# **Data Request:**

# TRIPLE H WIND PROJECT, LLC HYDE COUNTY, SOUTH DAKOTA

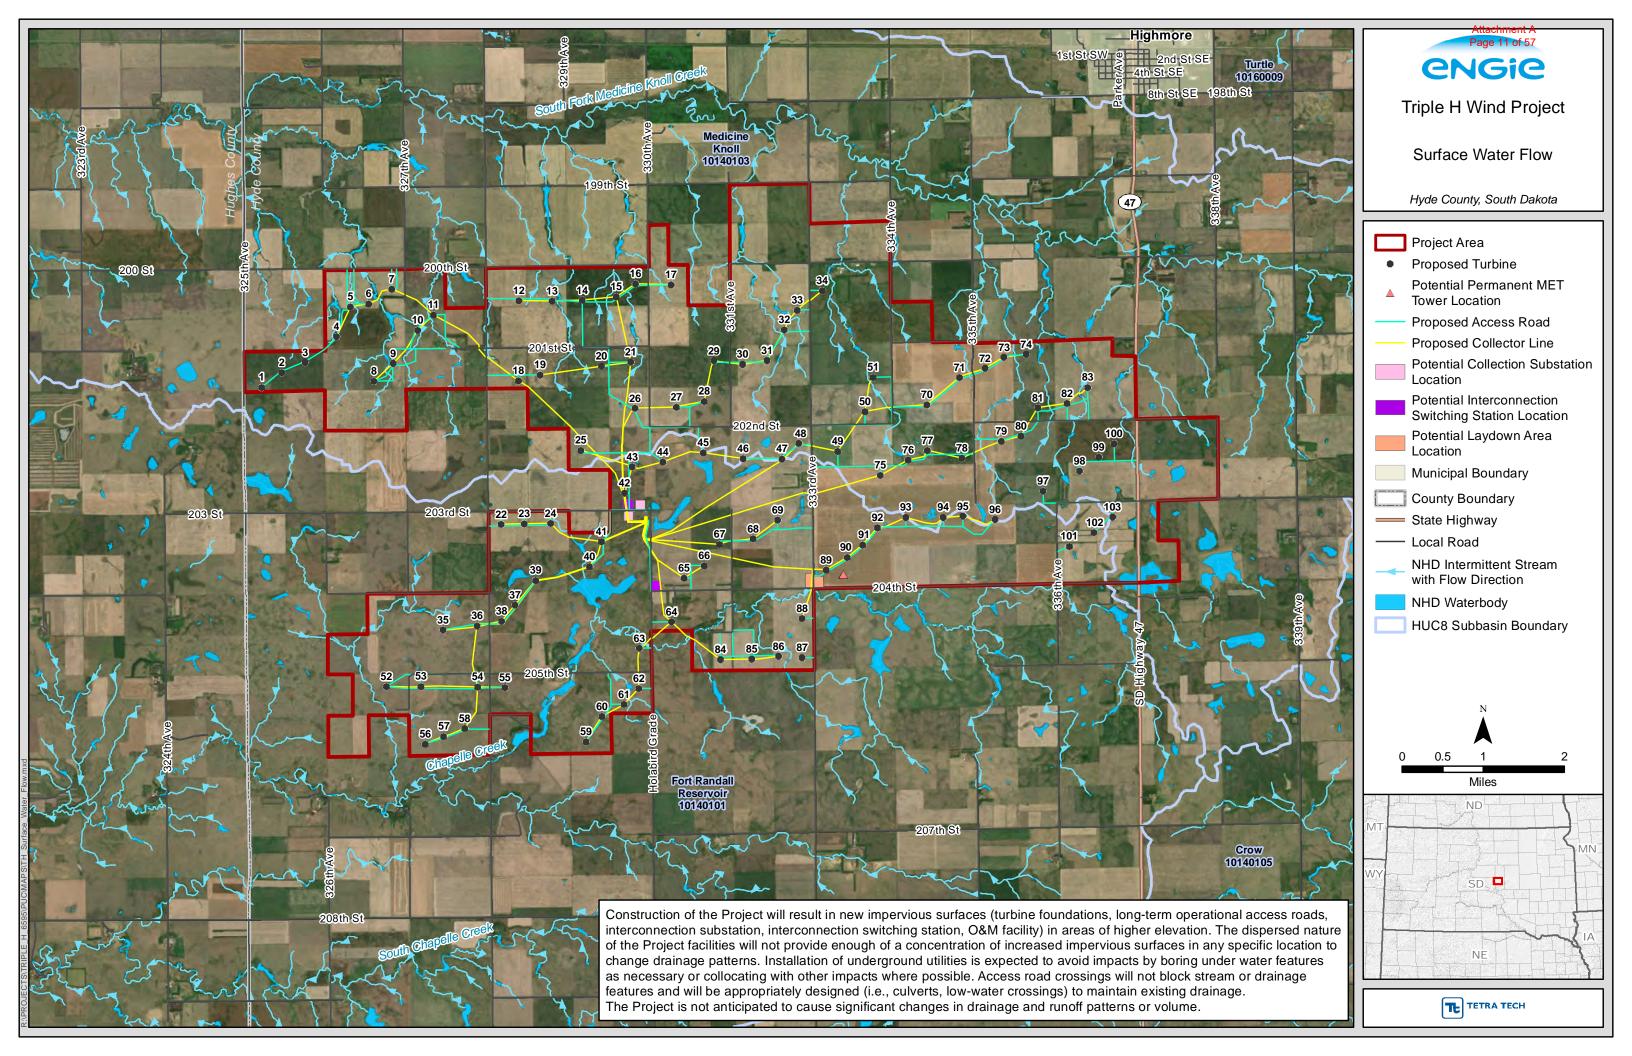
1-10) Per ARSD 20:10:22:15(1), provide a map showing surface water drainage pattern before and after construction of the facility. Use arrows to indicate the directed on any water flows.

Please see the attached map that shows the surface water drainage patterns for the Project.

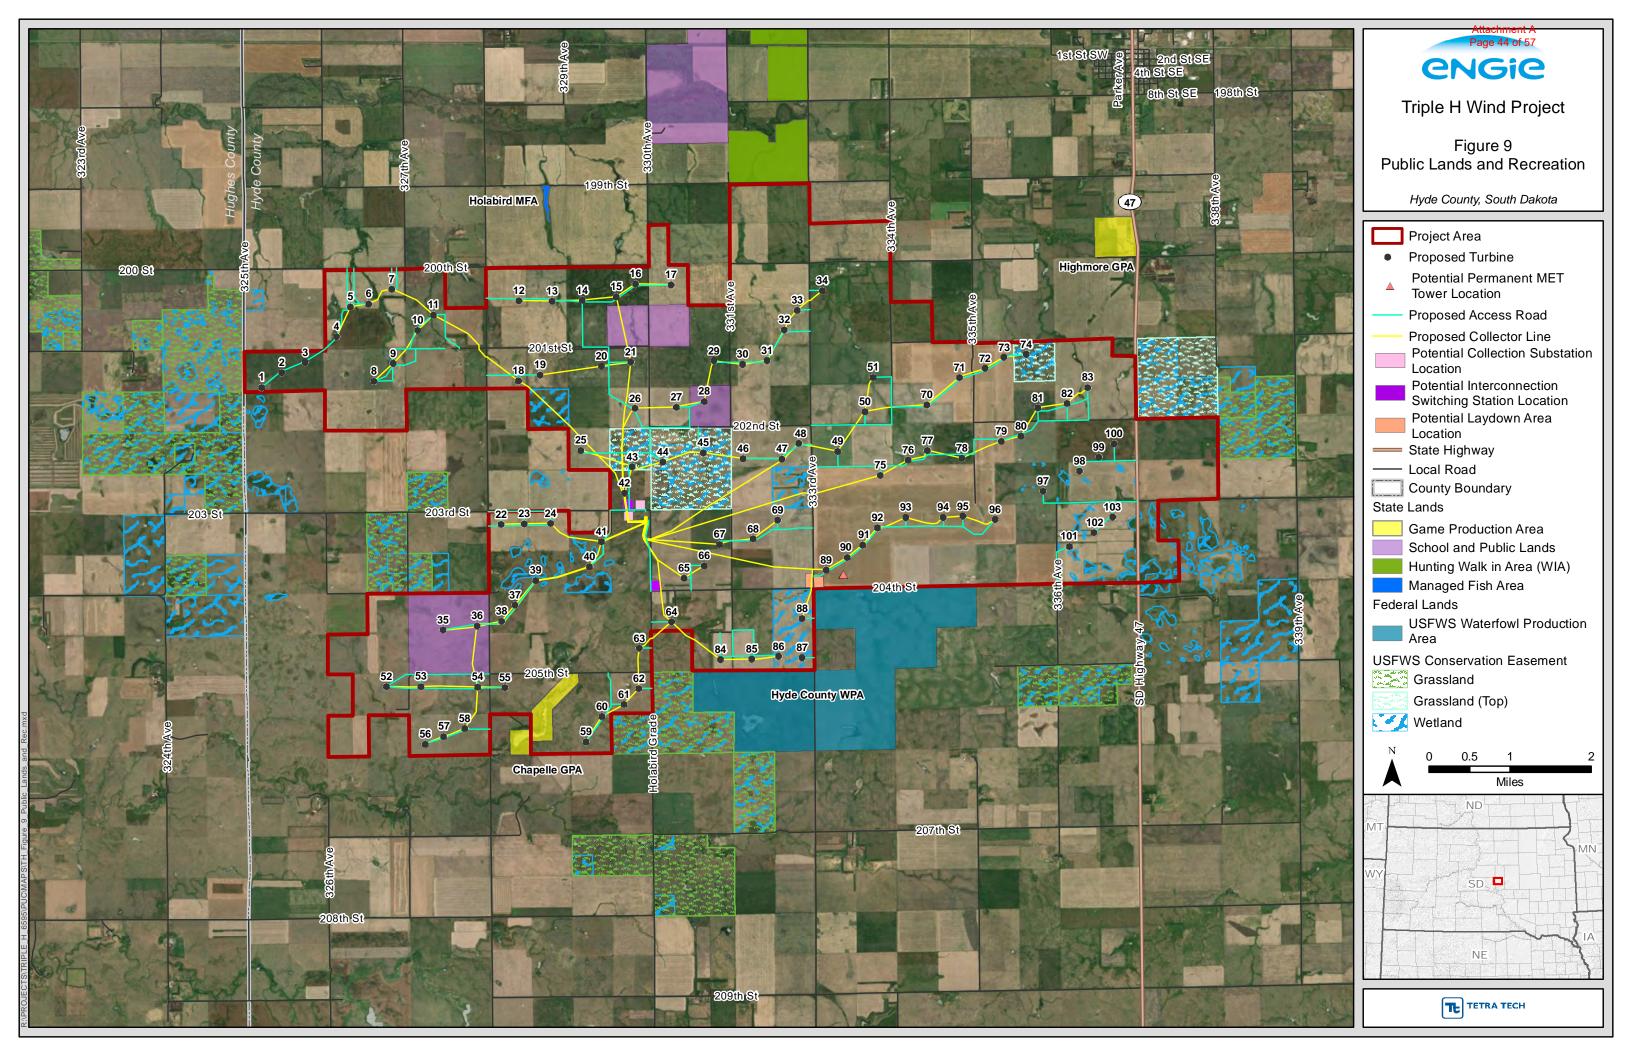
3-4) Pursuant to 20:10:22:11, please provide maps showing places of historical significance, transportation facilities, or other public facilities adjacent to or abutting the proposed wind energy facility. If there are none in or near the Project area, please indicate as such.
